ALLEGHENY COUNTY SANITARY AUTHORITY

CONTRACT NO. 1729 G, E, H, P

EAST HEADWORKS

ADDENDUM NO. 10

C-13
SITE PLAN - EAST

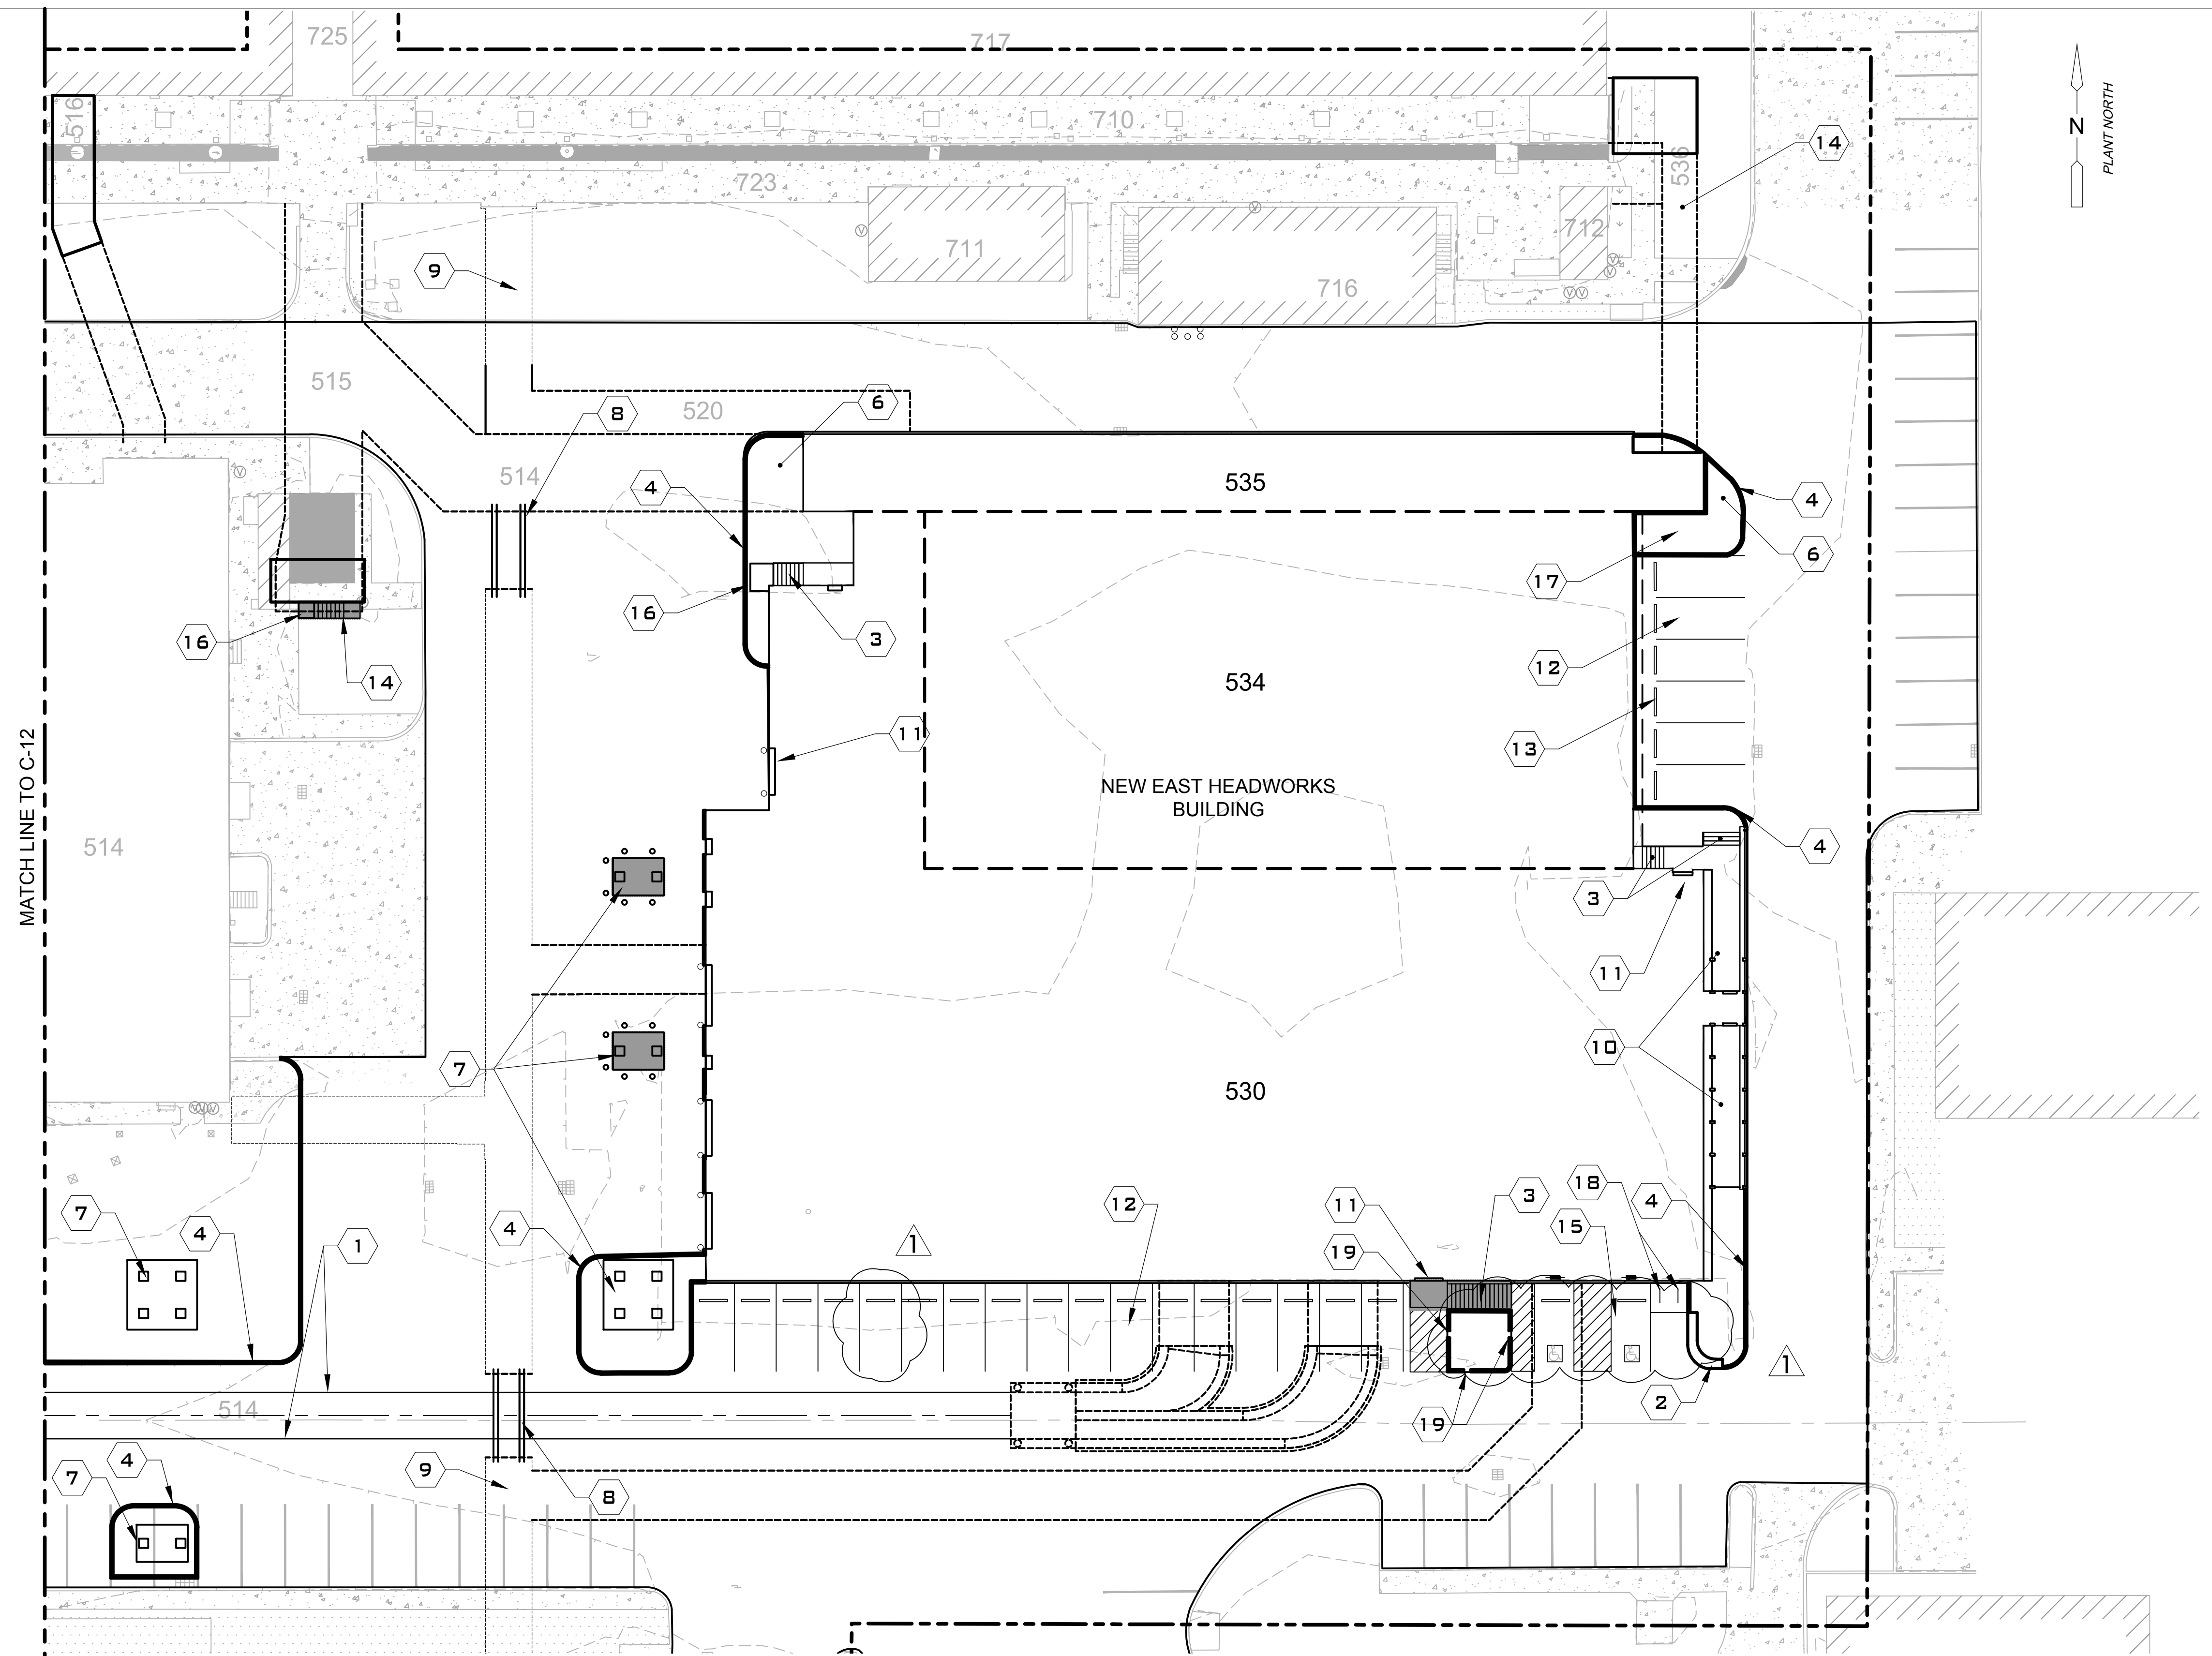
1. Drawing G-08
 - a) **ADD** the following under Pipe Materials,
“PVF Polyvinylidene Fluoride”
2. Drawing C-11
 - a) **DELETE** this drawing and **REPLACE** with the attached drawing C-11.
3. Drawing C-13
 - a) **DELETE** this drawing and **REPLACE** with the attached drawing C-13.
4. Drawing C-21
 - a) **DELETE** this drawing and **REPLACE** with the attached drawing C-21.
5. Drawing C-22
 - a) **DELETE** this drawing and **REPLACE** with the attached drawing C-22.

**C-22
YARD PIPING PLAN - EAST**

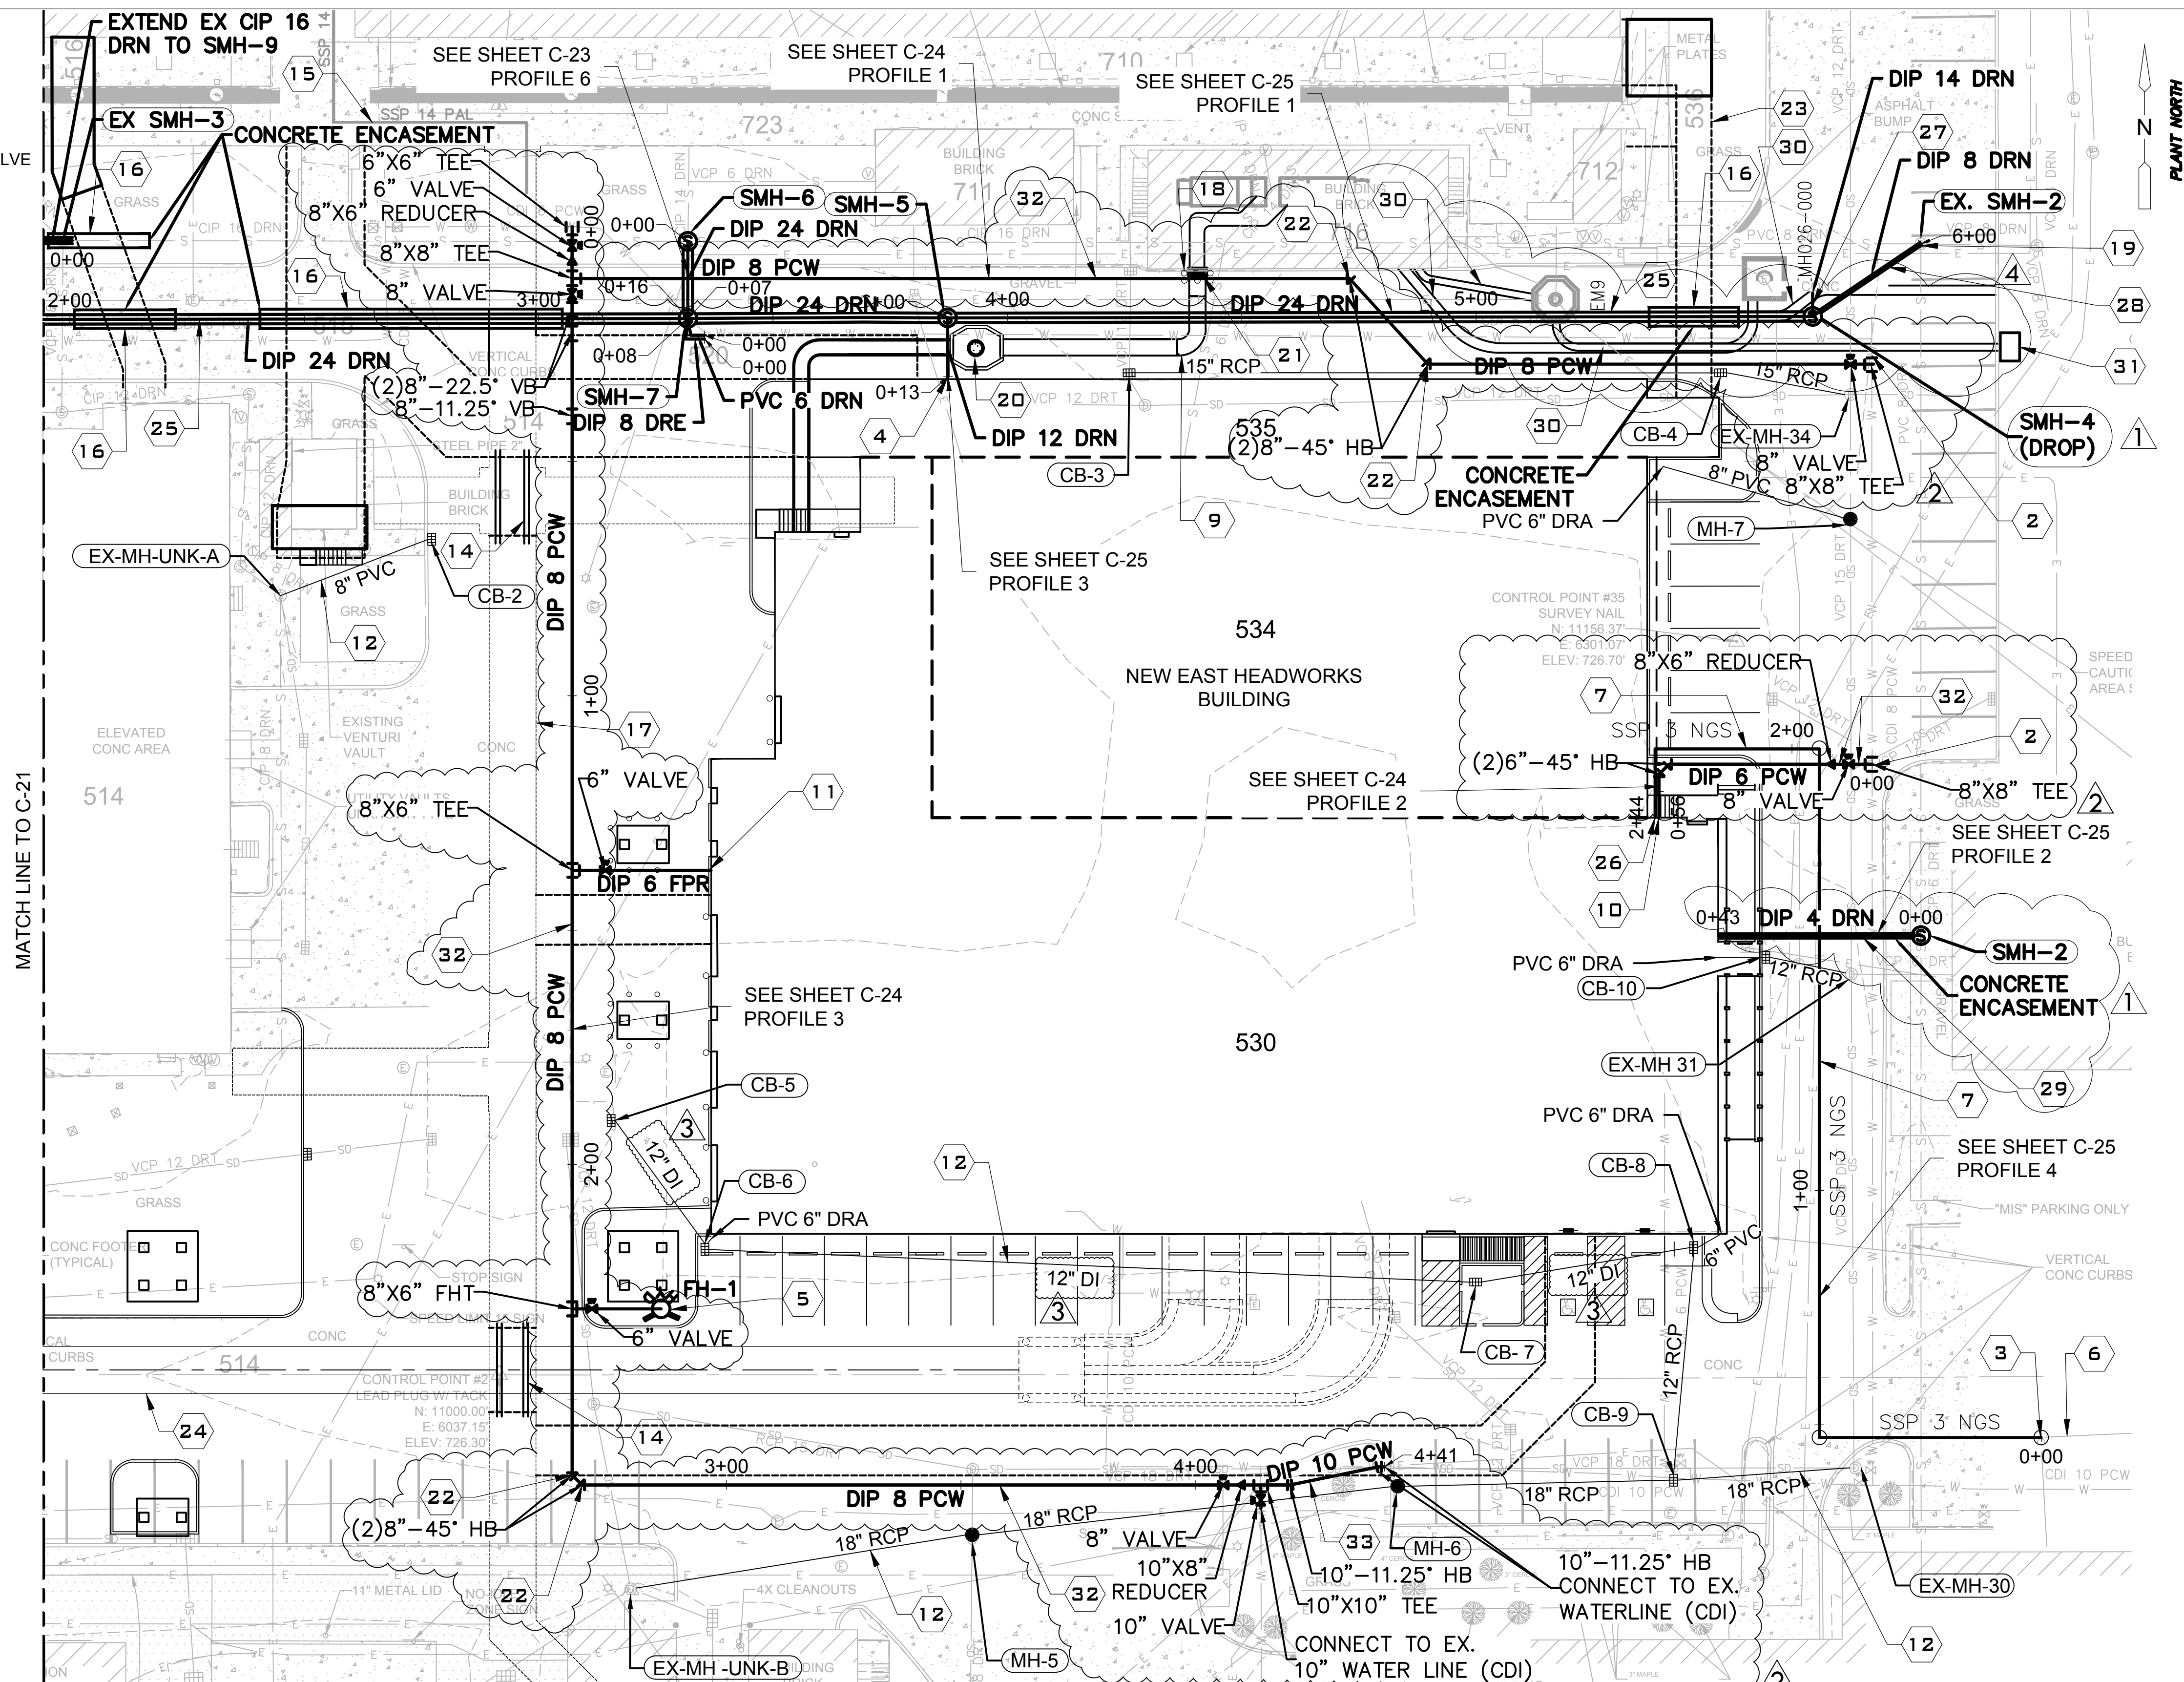
“5. A portion of the plant drain system including Manhole SAN MH-4 to SAN MH-5 will need to be installed and backfilled to grade by September 30, 2021. This work needs completed to allow timely installation of the new duct bank system noted to be installed in Contract 1739 on Drawing C-22 by Keynotes 30 and 31.”
